DRAFT - Prototypes Catalog and Potential Code

Hood River Housing Prototypes

Date December 14, 2020
To Dustin Nilsen - City of Hood River
From Ben Weber, Ross Determan, Emma-Quin Smith, and Elise Chelak – SERA

PURPOSE

DETACHED DUPLEX

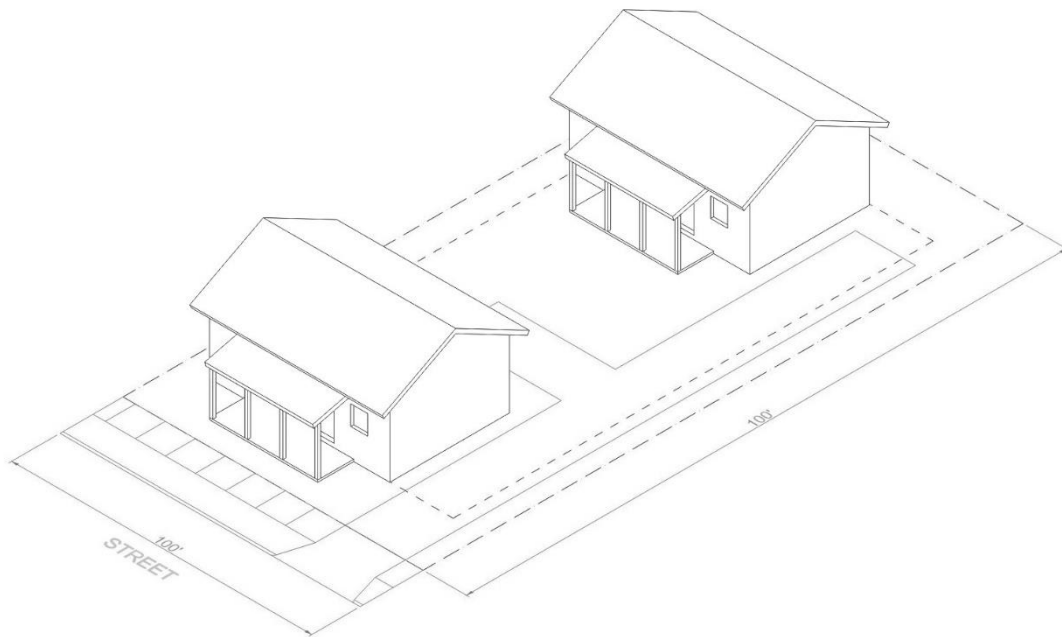
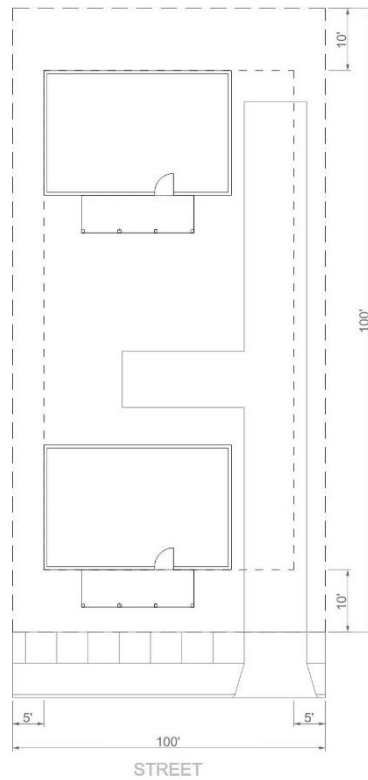
- Porches permitted or restricted in front setback?
- Any thoughts on parking configuration?

THREE DWELLINGS

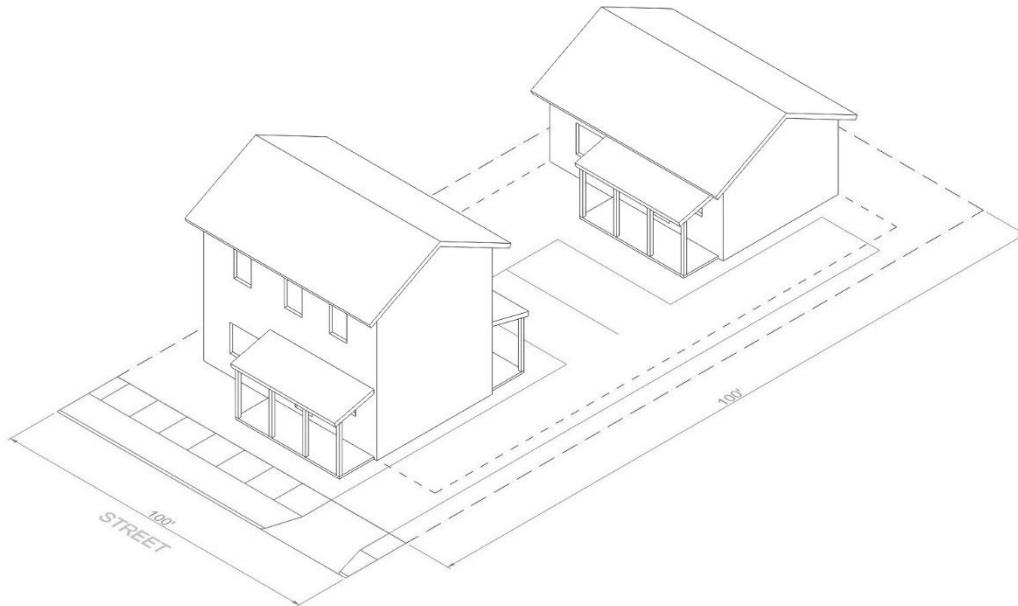
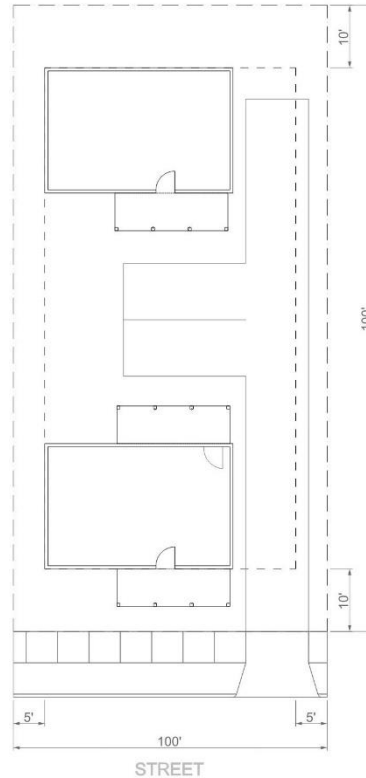
- Porches permitted or restricted in front setback?
- Any thoughts on parking configuration?
- ADUs: Would Hood River allow them on a duplex/triplex lot? Requires amending 17.23.010(B).

DETACHED DUPLEX – V1

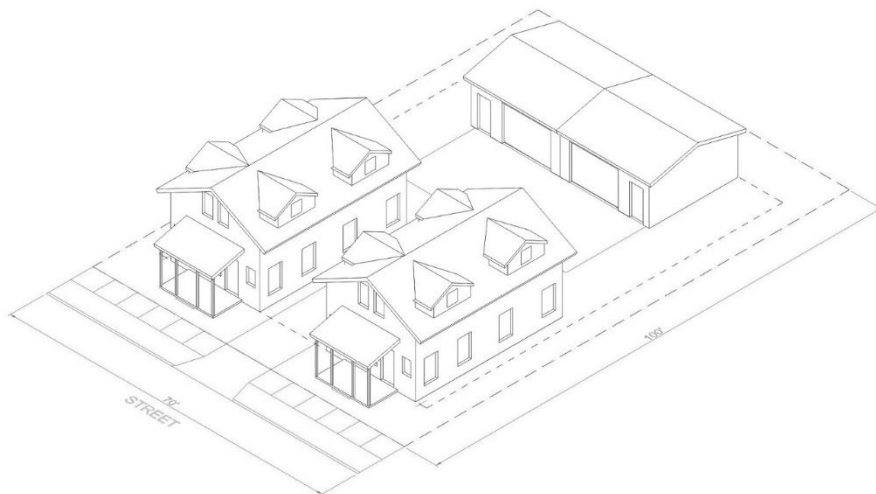
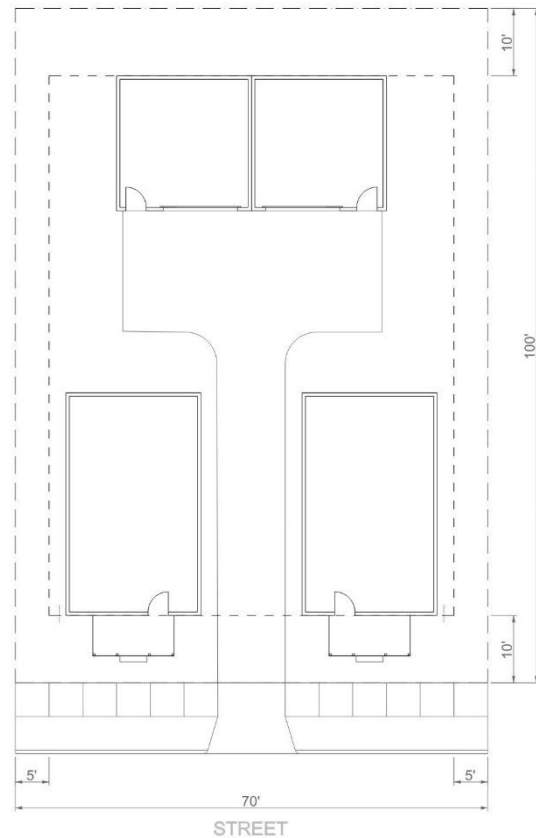
- Permit porches in front setback?
- Garages consolidated to the rear-center to reduce driveway paved area and leave larger side yard open space – any thoughts about this design?
- ADUs: Would Hood River allow them on a duplex/triplex lot? Requires amending 17.23.010(B).

DETACHED DUPLEX – V2

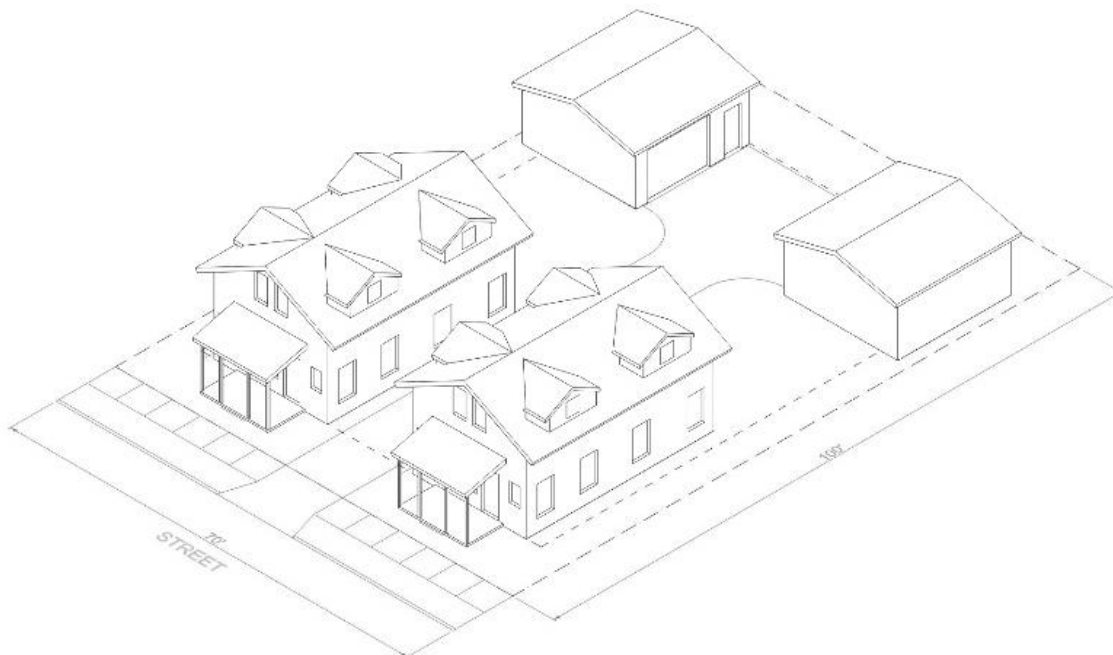
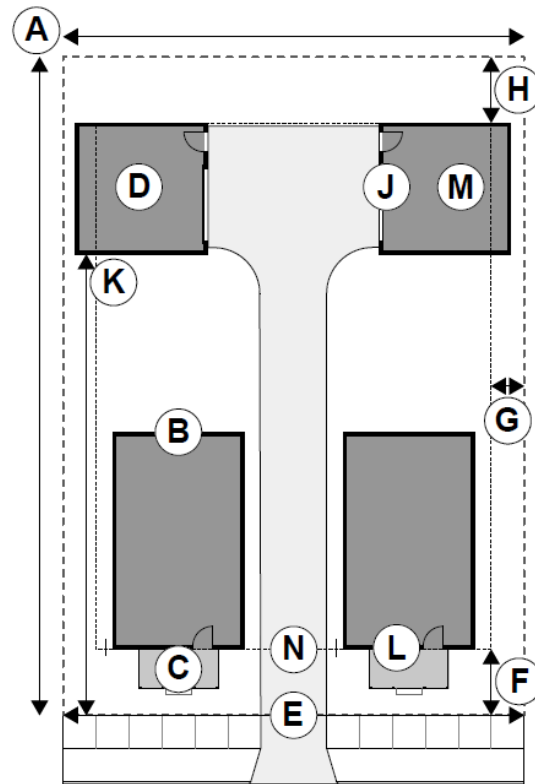
- Permit porches in front setback?
- Permit or not a partial encroachment of garage in side-yard setback? Impacts vehicle turning radius.
- ADUs: Would Hood River allow them on a duplex/triplex lot? Requires amending 17.23.010(B).

ATTACHED TRIPLEX PAIR

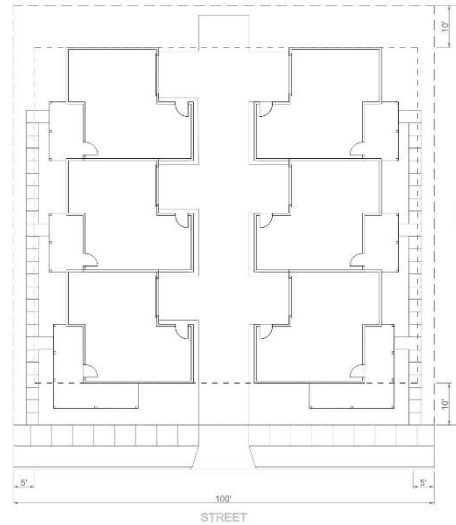
- Permit porches in front setback?
- Does prototype provide enough open space for each dwelling?
- Questions...

DETACHED TRIPLEX PAIR

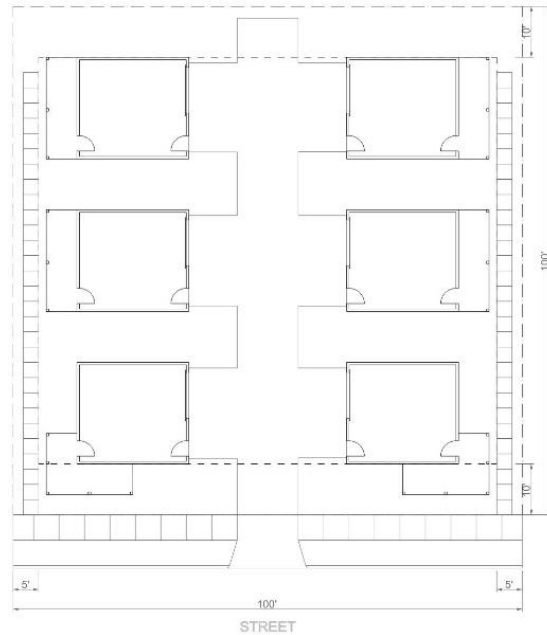
- Permit porches in front setback?
- Does prototype provide enough open space for each dwelling?
- Is prototype dwelling size big enough?

COTTAGE CLUSTER

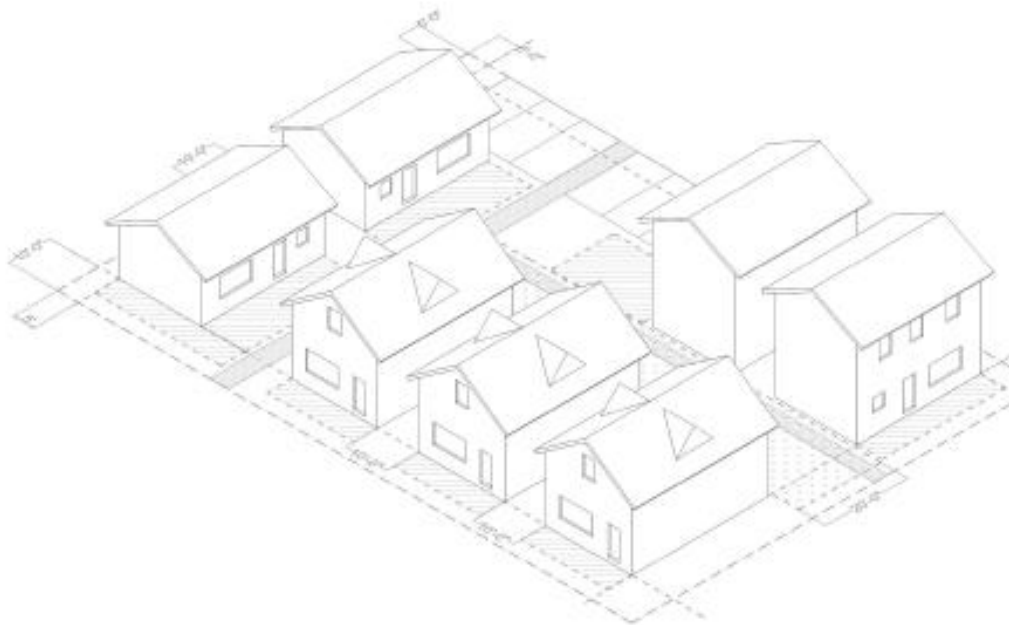
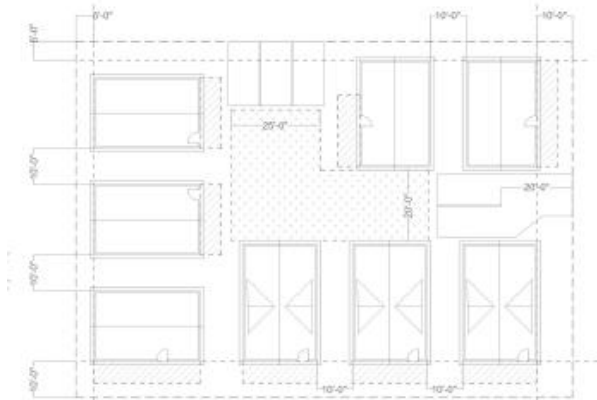
- Should cottages be regulated by an average dwelling size maximum?
- How should private versus public open space be required?

DETACHED DUPLEX PAIR

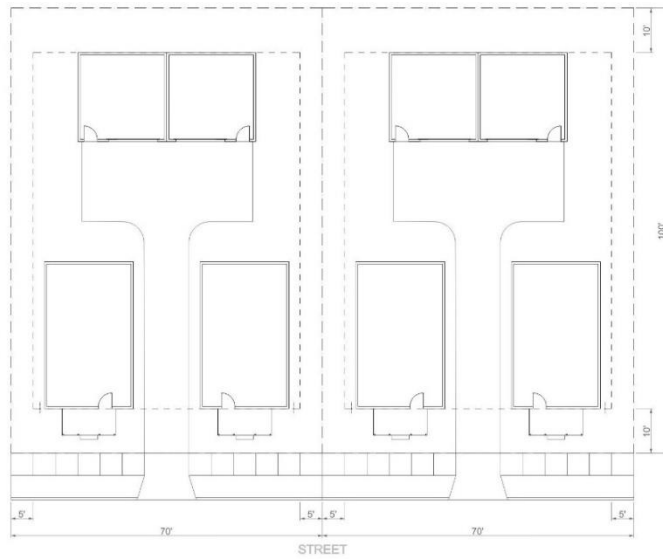
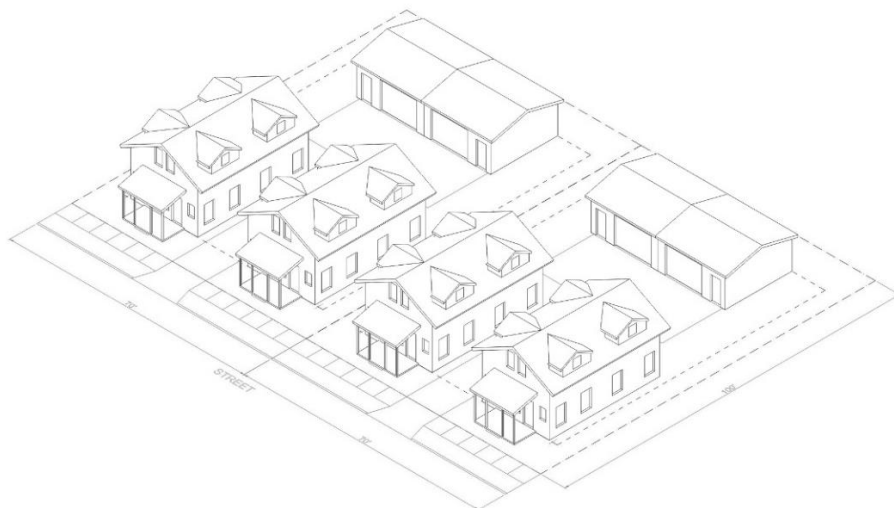
- Porches permitted in front setback?
- Garages consolidated to the rear-center to reduce driveway paved area and leave larger side yard open space –thoughts about this design?
- Make units larger? Would increase footprint/coverage.
- ADUs: Would Hood River allow them on a duplex/triplex lot? Requires amending 17.23.010(B).

DETACHED TRIPLEX PAIR – V1 (UNUSED)

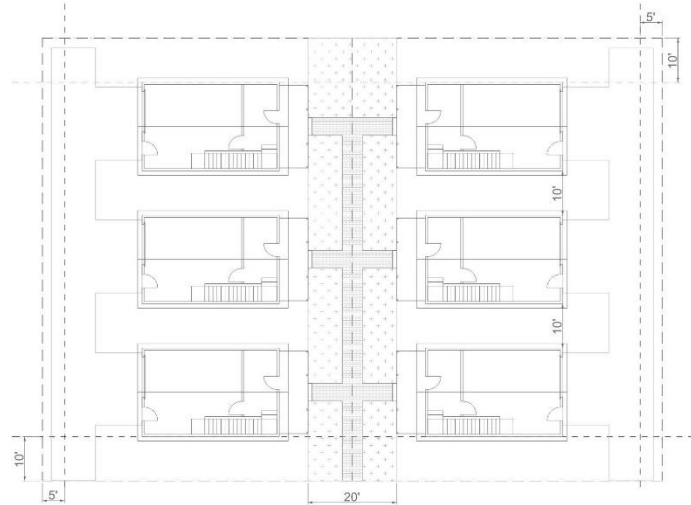
- Permit porches in front setback?
- Does prototype provide enough open space for each dwelling?

DETACHED TRIPLEX PAIR – V2

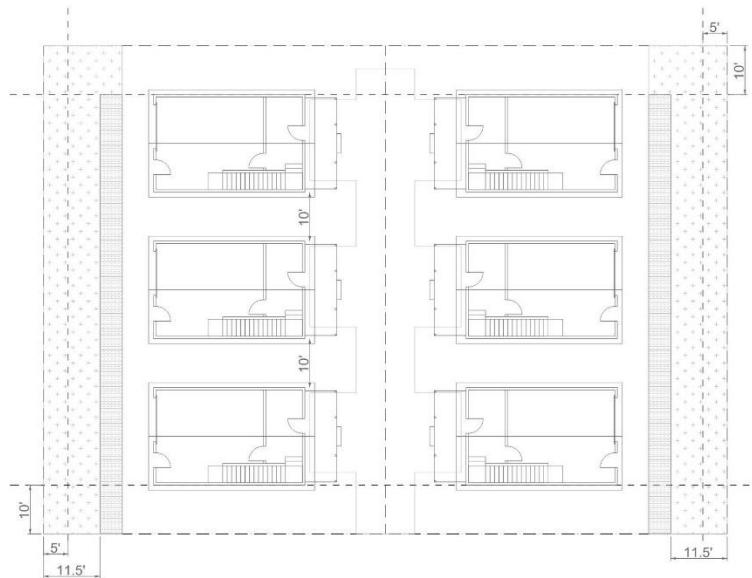
- Permit porches in front setback?
- Does prototype provide enough open space for each dwelling?
